DATE: September 18, 2023
TO: All Bidders
FROM: Renée Knight, Purchasing Specialist
SUBJECT: Addendum 1 – Bid #657, Oxnard College Automotive Technology Vehicle Lift

ADDENDUM 01

OXNARD COLLEGE AUTO TECH
Ventura Community College District
4000 S Rose Ave.
Oxnard, CA 93033

Item No. AD-01-1 **RFI responses**

A830

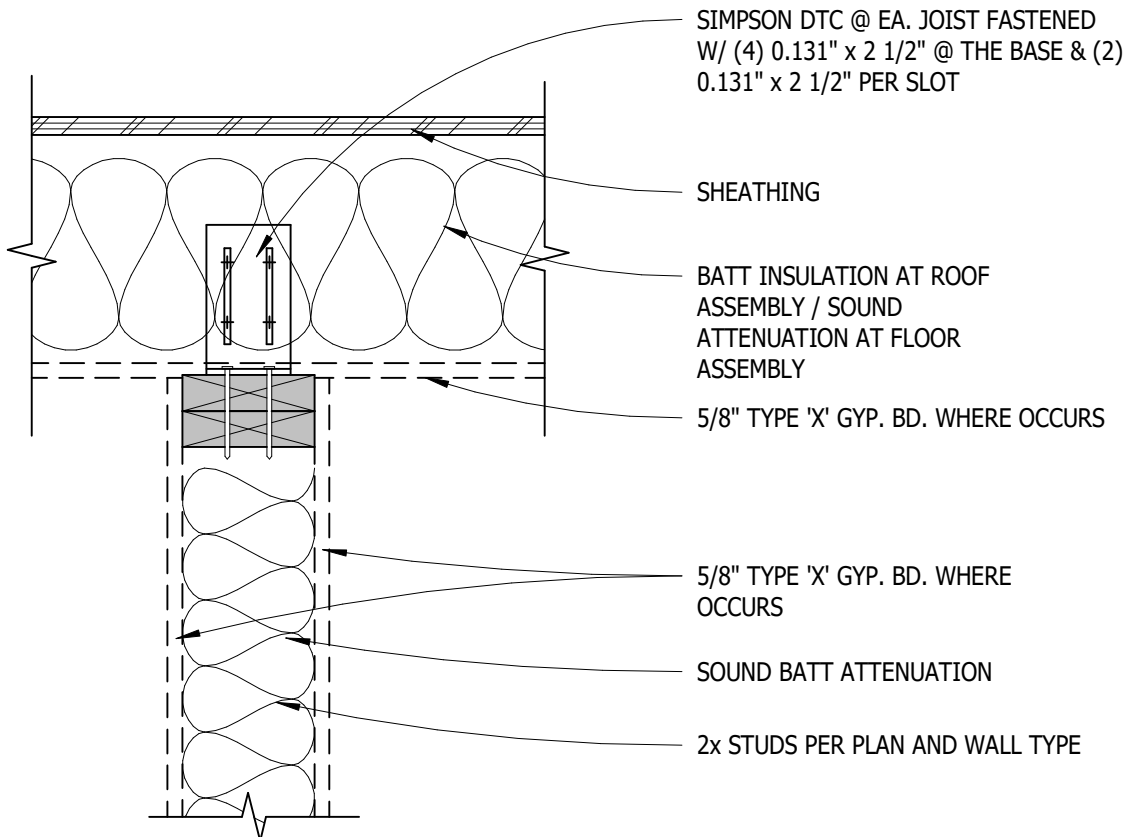
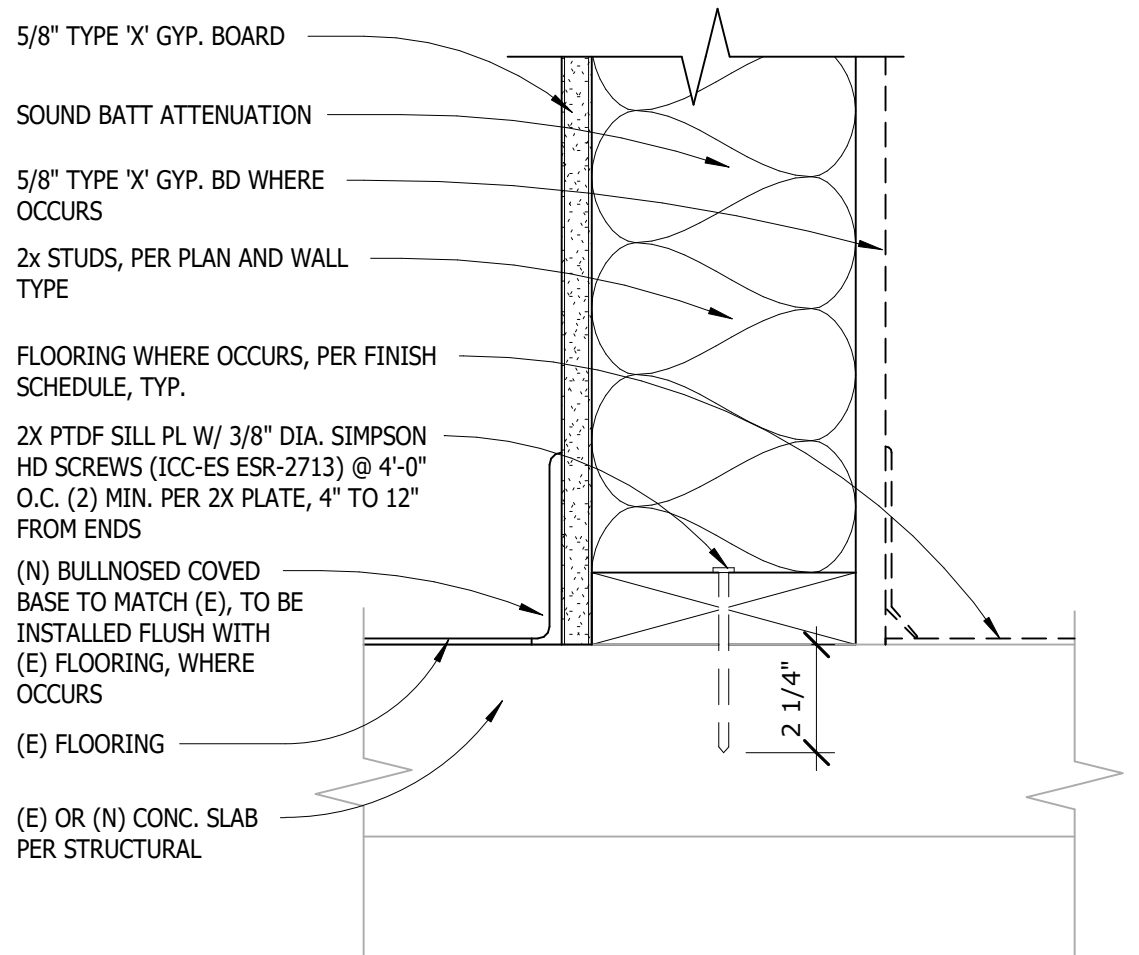
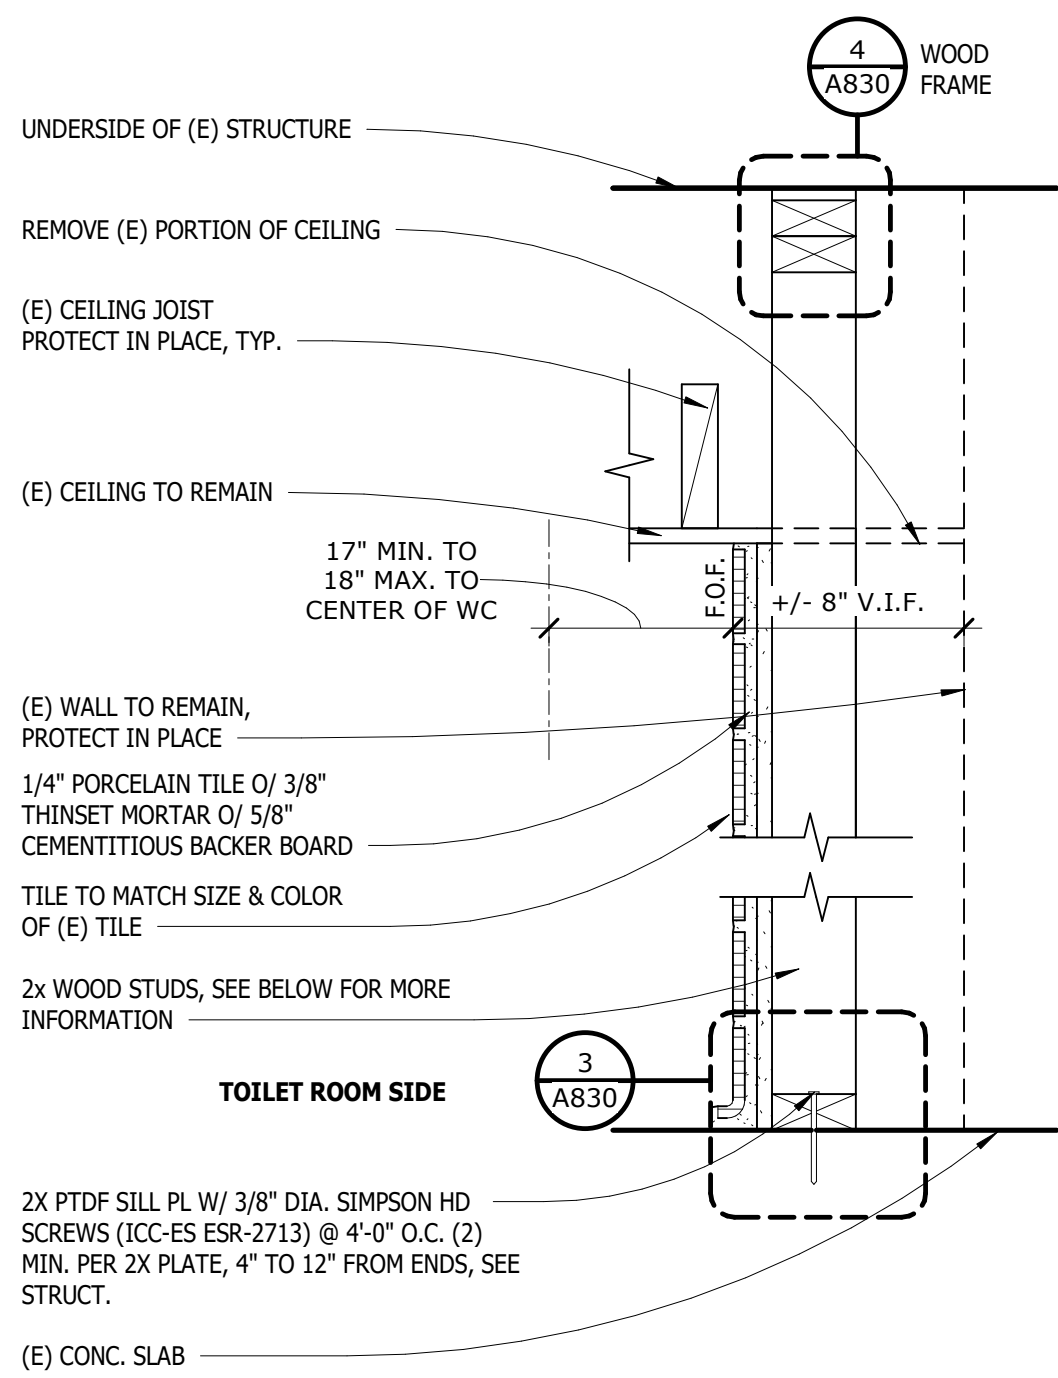
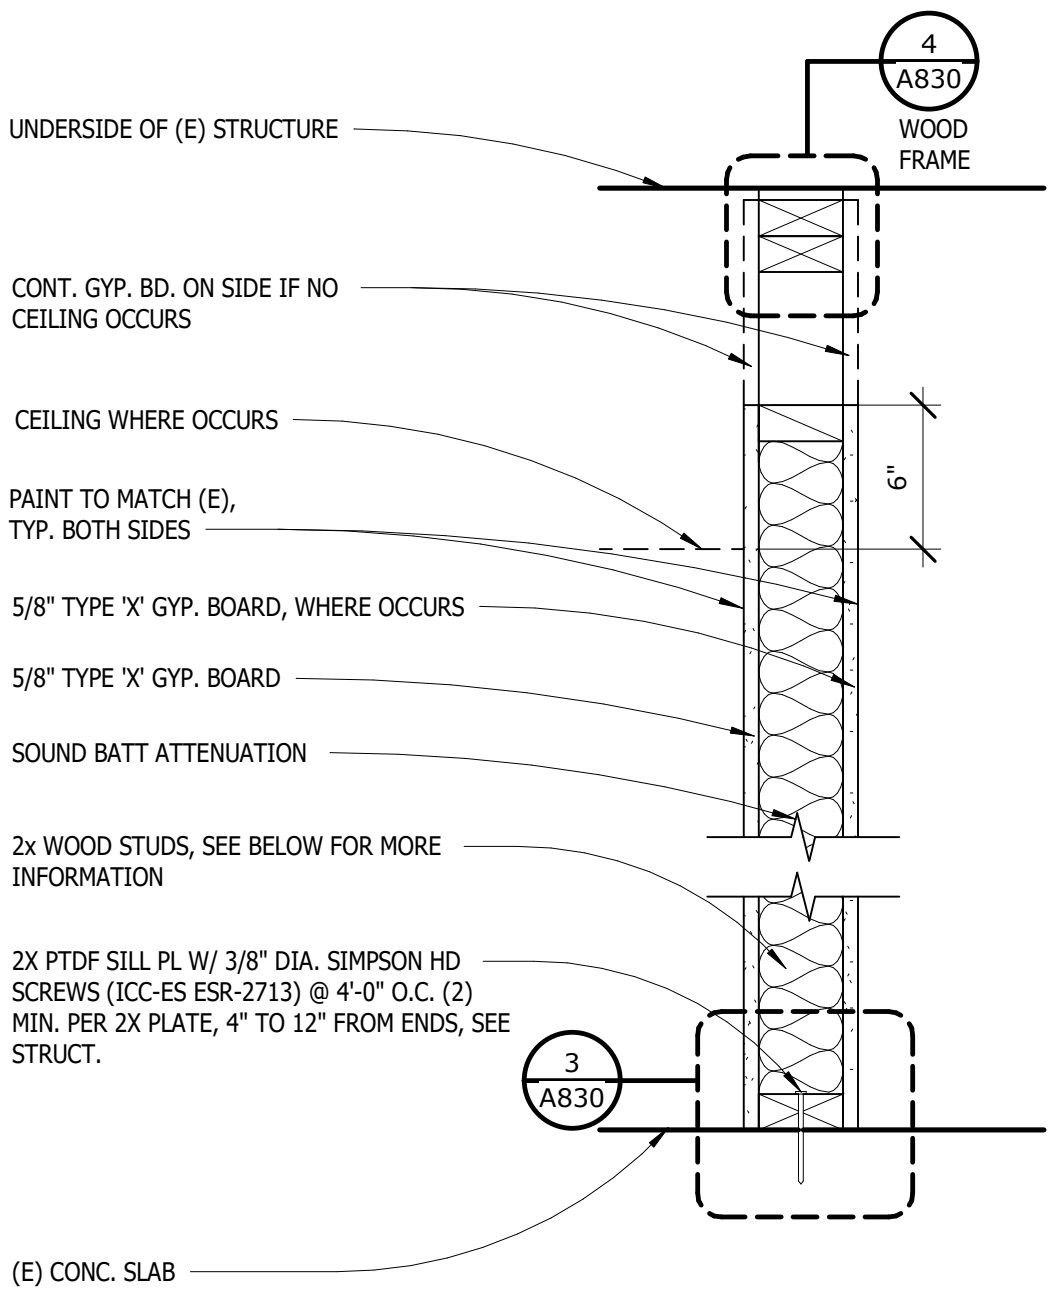
2. A830 Wall Types

- a. 5/A830: Added a new Wall Type 2.

SHEET DESCRIPTION:
ENLARGED DEMOLITION AND
REMODEL RESTROOM PLANS

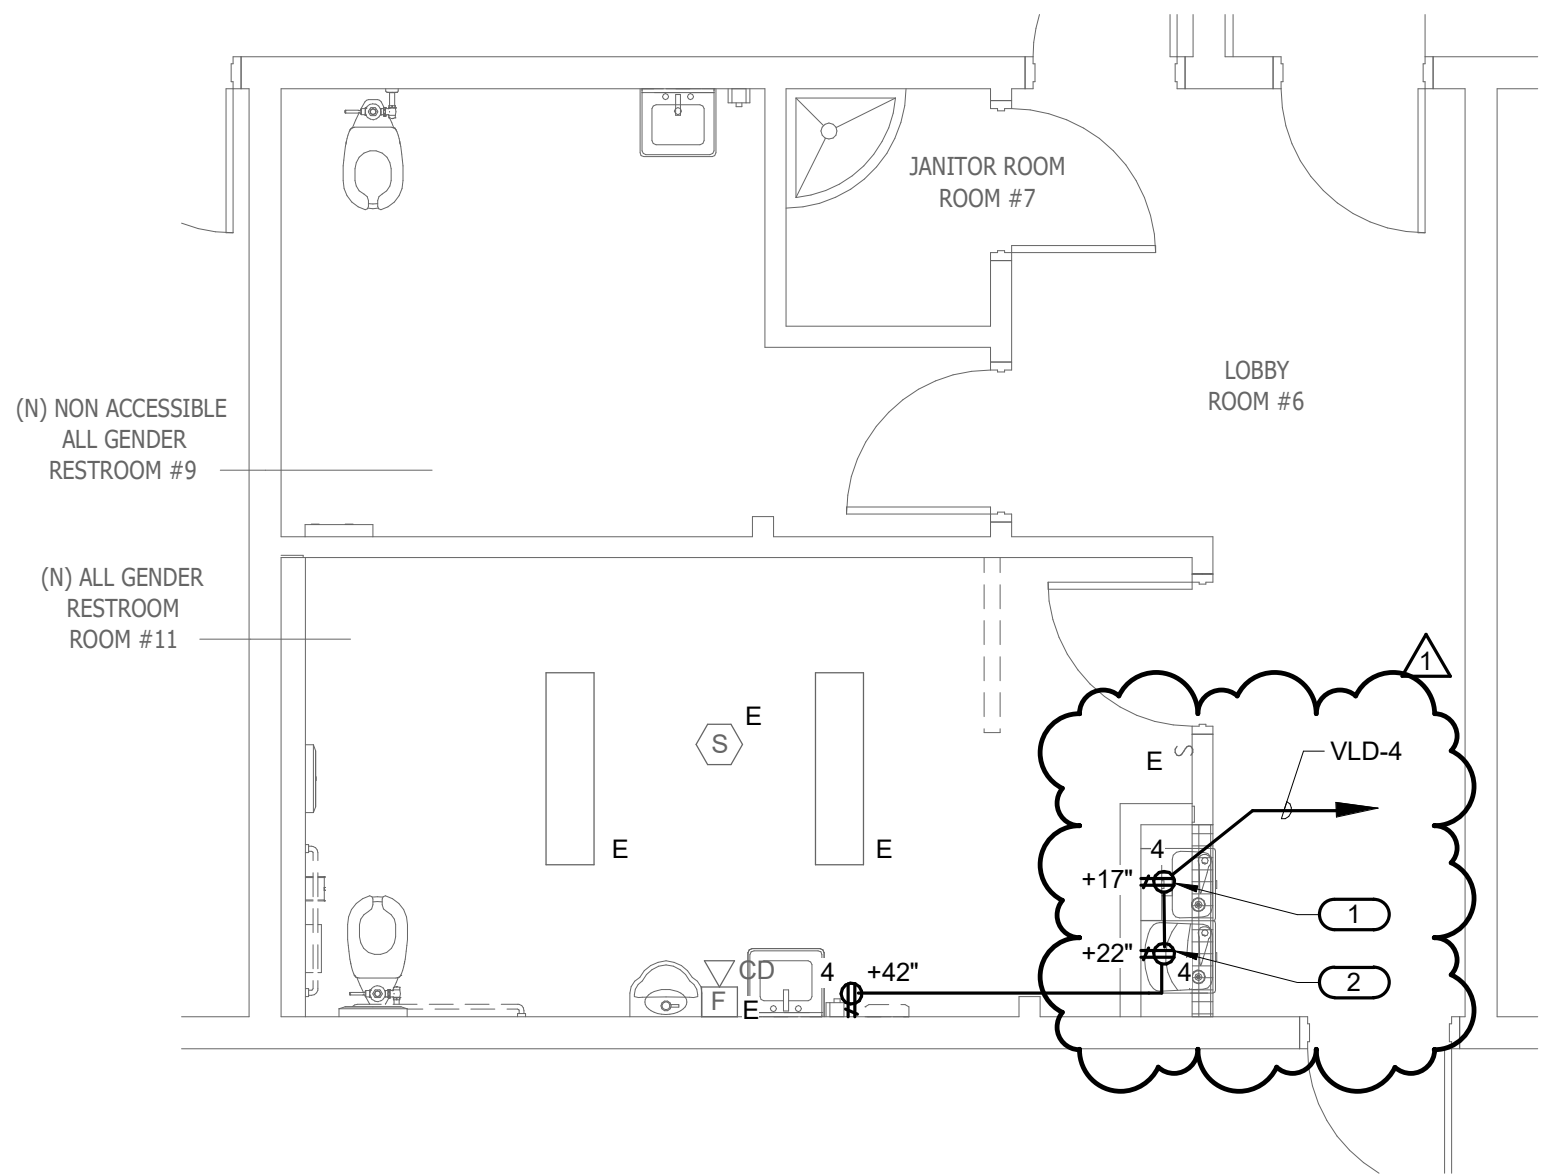
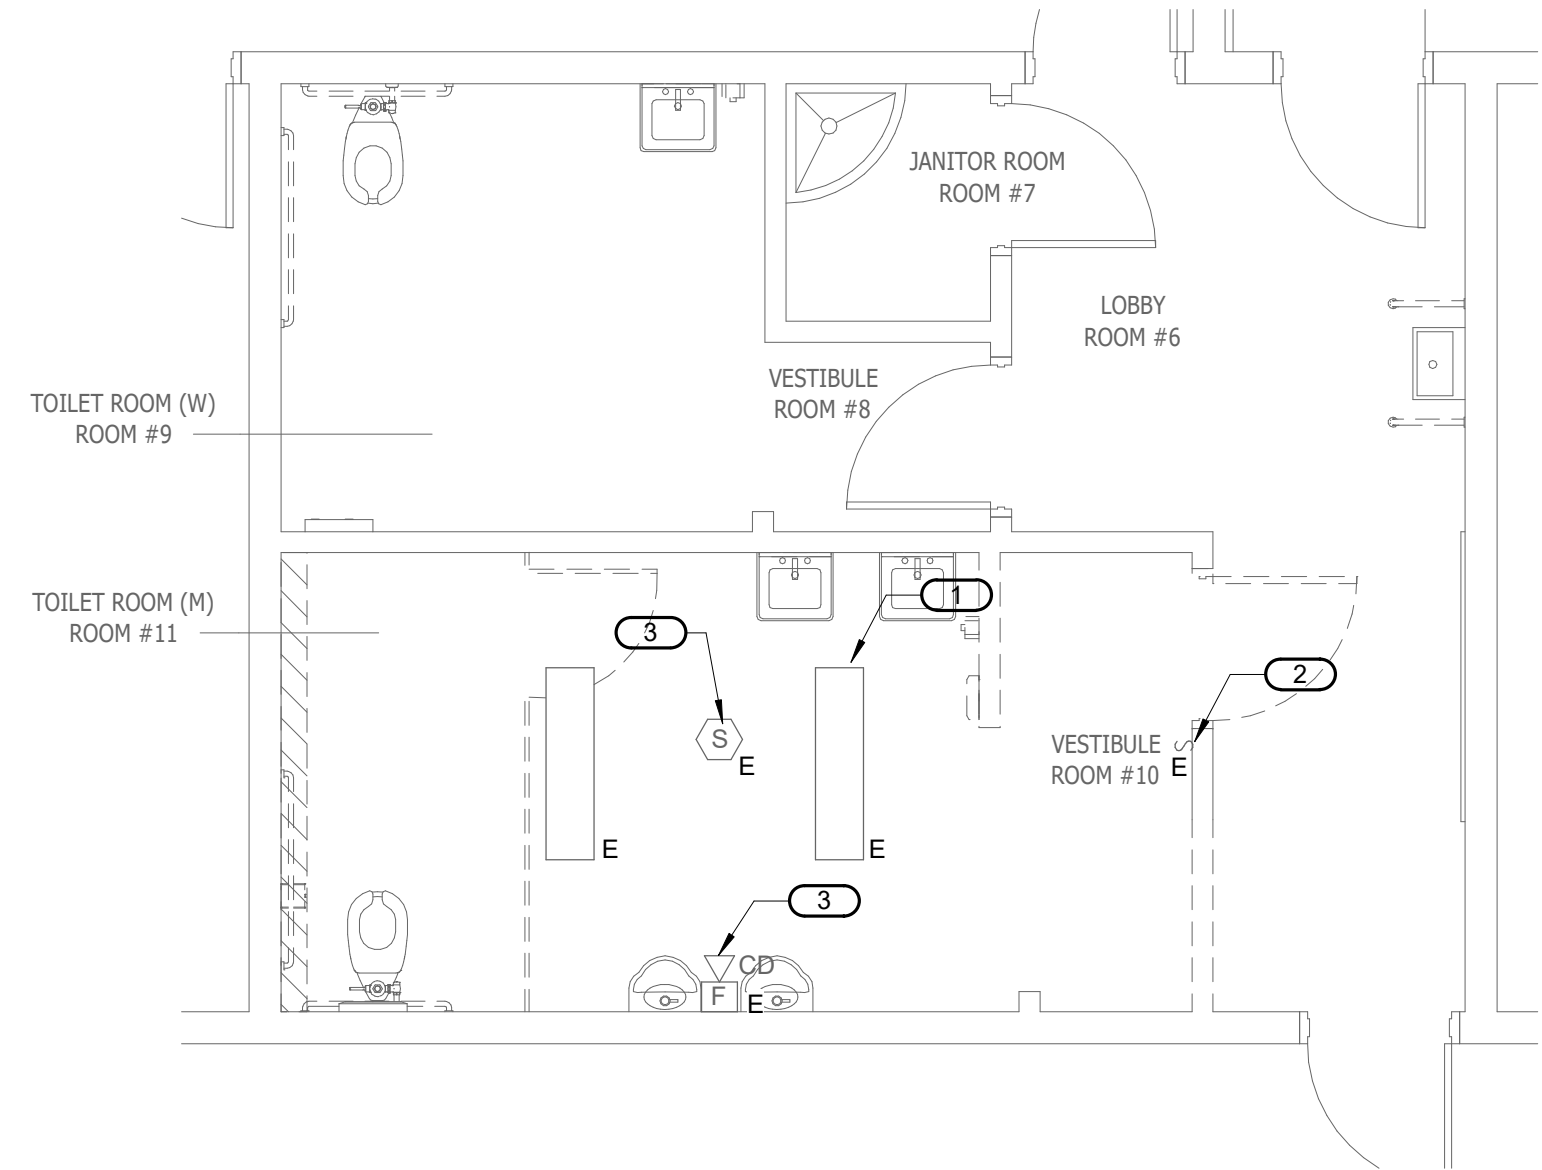
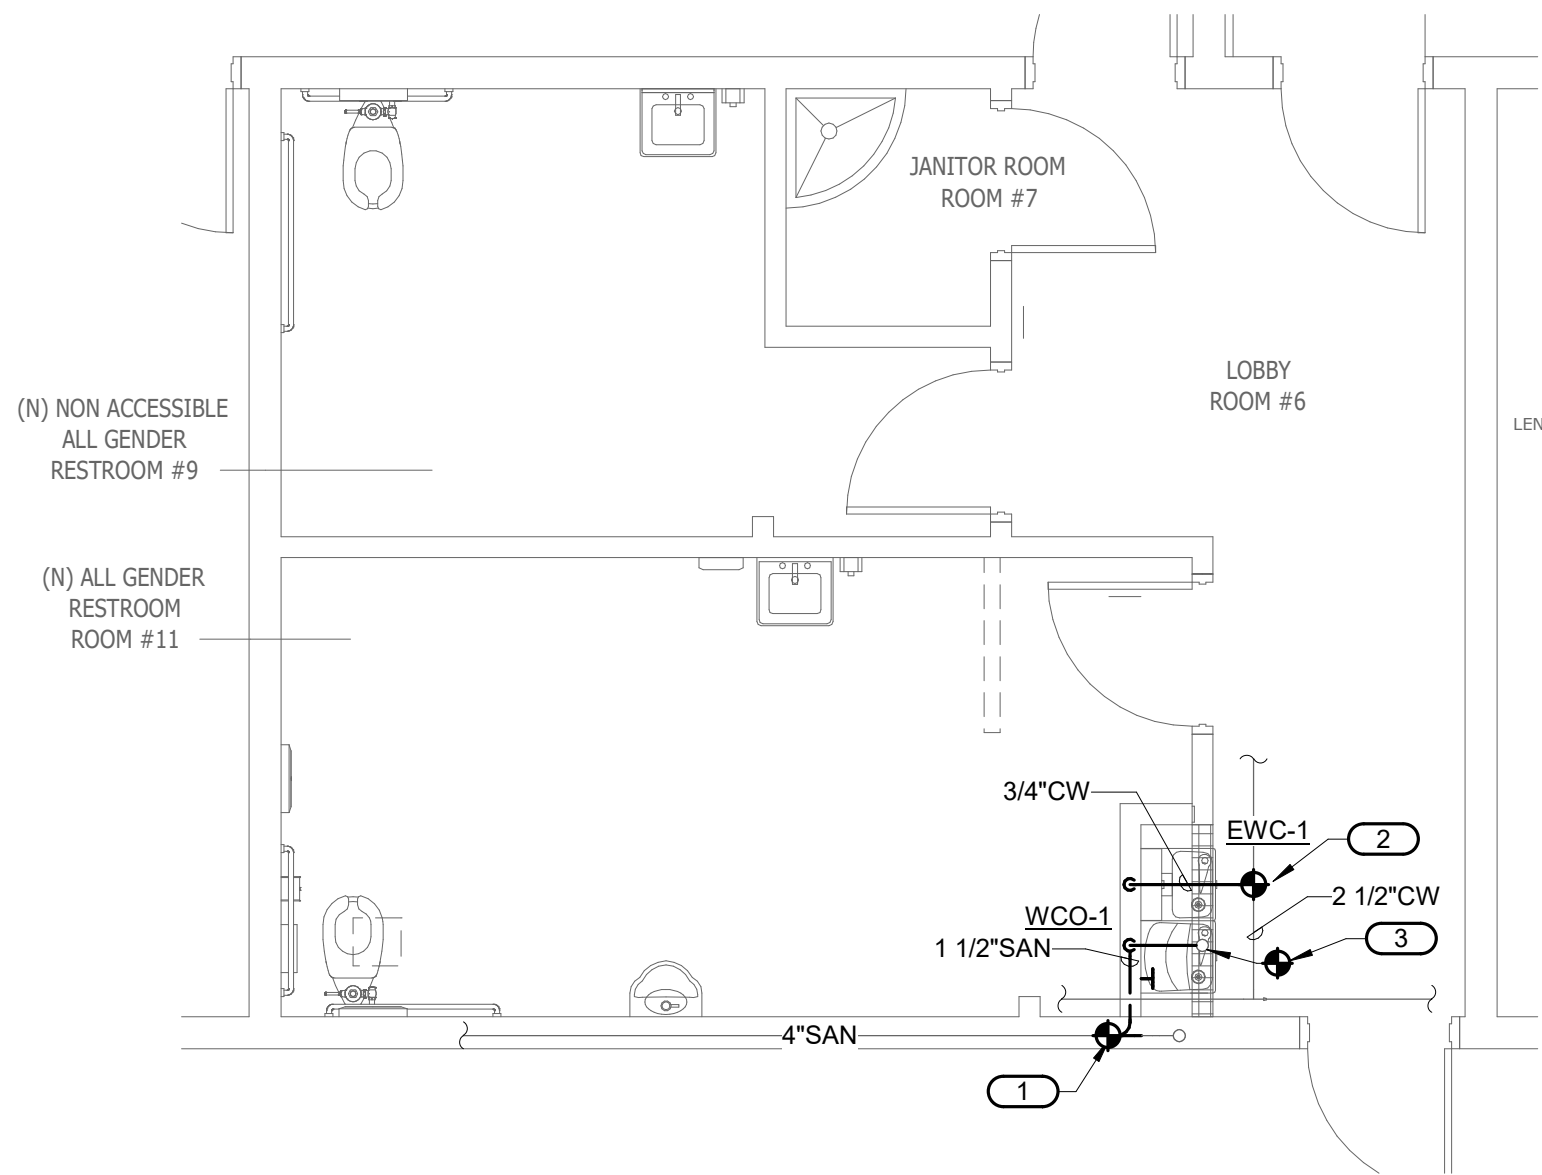
2. E202 Enlarged Demolition and Remodel Plan

- a. Added power connect for the new drinking fountain.
